Memorandum
Planning and Urban Development Department
Planning Division

To: Elizabeth Boepple, Chair, and Members of the Portland Planning Board
From: Nell Donaldson, Planner
Date: July 21, 2016
Re: Mixed-Use Development, 23 Ocean Avenue
Project #: 2016-150 **CBL:** 129-G-1
Meeting Date: July 26, 2016

Figure 4: Preliminary site plan

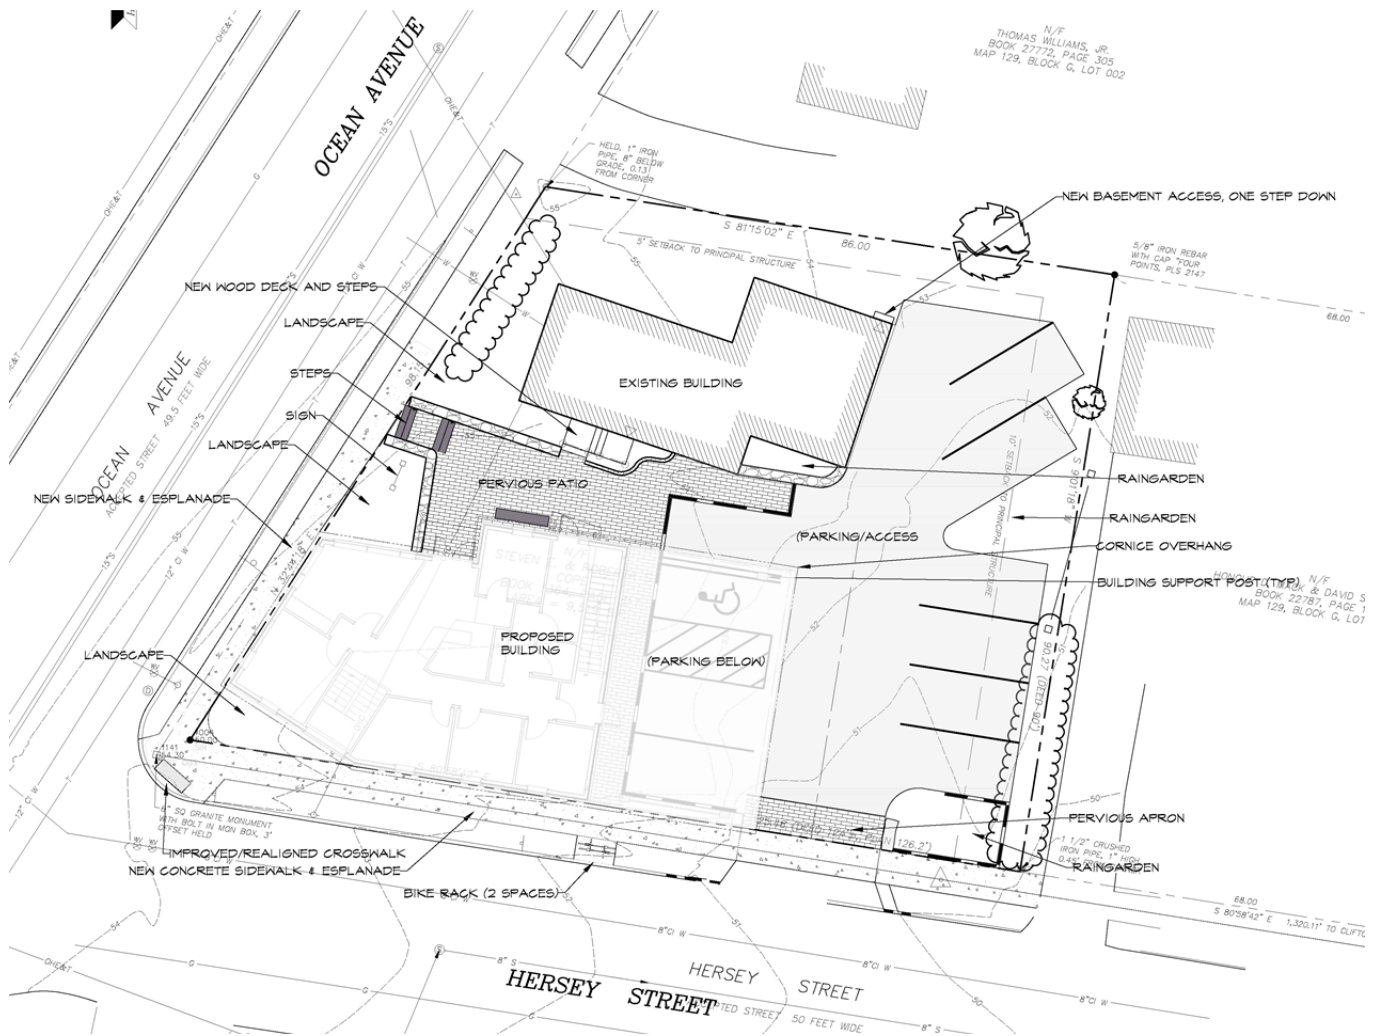
The plans do not include full replacement of the sidewalk on Ocean Avenue along the entire property frontage. The applicant should either include full sidewalk replacement or document justification for the current proposal.

Further review of the sidewalk ramp configuration is required. I would suggest that a fully ADA compliant ramp be provided on the opposite side of Hersey Street.

I find the driveway location and configuration to be acceptable given existing site conditions. A detail for the driveway shall be provided that notes that the crossslope shall not exceed 2%.

I would prefer that backing maneuvers onto Hersey Street not be required and thus the applicant should either provide a layout that allows for onsite vehicle circulation – for headout egress, or supporting documentation on the proposed circulation condition.

The applicant is requesting a waiver for parking lot aisle width (21 feet versus the City standard of 24 feet). The applicant should provide documentation that supports the waiver request.

[P]arking lot on Hersey Street should have a 4' buffer with plant material at back of sidewalk. A smaller 3' or 2' buffer might not make it. Ideally like to see woody shrub planting but could do ornamental grasses. Wood guardrail on the parking lot side is needed to protect this space from vehicles, snow etc. Without protection plant material would likely be damaged. This buffer on the residential side is more important than the more commercial Ocean Avenue side. Add a couple of trees on the parking lot edge to buffer parking lot from next door residential use. See photos (Attachment 4).
